1047-1071 BRIGHTON AVENUE

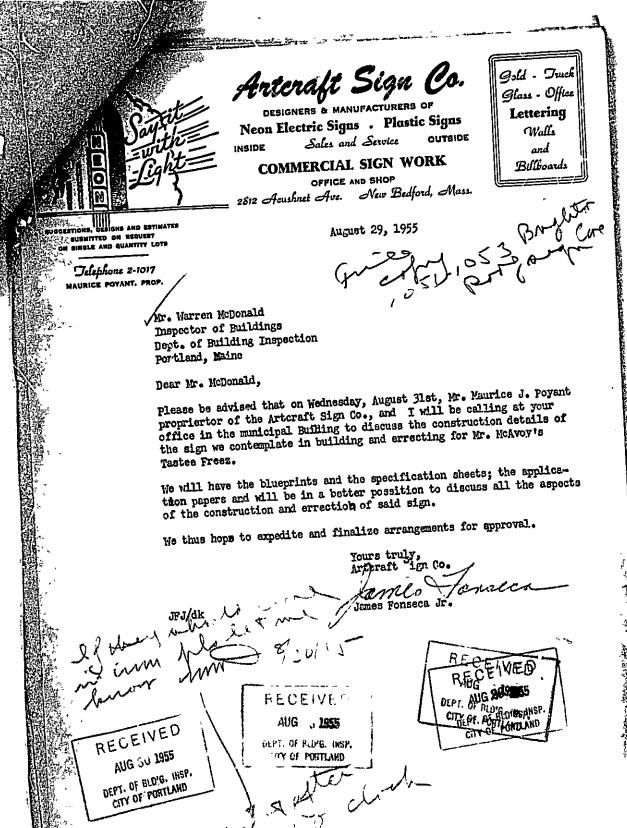
Mr. Fonseca had with him a set of blueprints, which were apparently hade by Mr. McAvoy's proprietary Co. (The Tastes-Fresse people). We discovered that these typical plans call for a very heavy built up beam running along the center line of the roof from the cross bearing partition toward the front running over the steel beam and thence to the edge of the curved roof. On the other hand Mr. McAvoy's plan shows up joist or beam at all on the center line, but only a single 2x10 on each aide of the center line and about eix inches from it.

It becomes clear that the single 2210s are loaded right up to their capacity in their cantilever section by the normal dead and live loads of the roof. Thus, there is no strength left in them at all to support the upright of the sign (a weight of about 200 pounds). Prom information given by Er. Fonseen it appears that this upright of the sign nearer Erigmon ave. will be about six feet out on the cantilever from the steel beam.

help Mr. Havey got the situation cleared up, we cannot proceed to design the exerc structural members which will be needed to support the sign. The lesuance of the sign permit to the interaft dign to, will, of course, have to exact the receipt of a plan shooting atructural members to fully support the proposed sign.
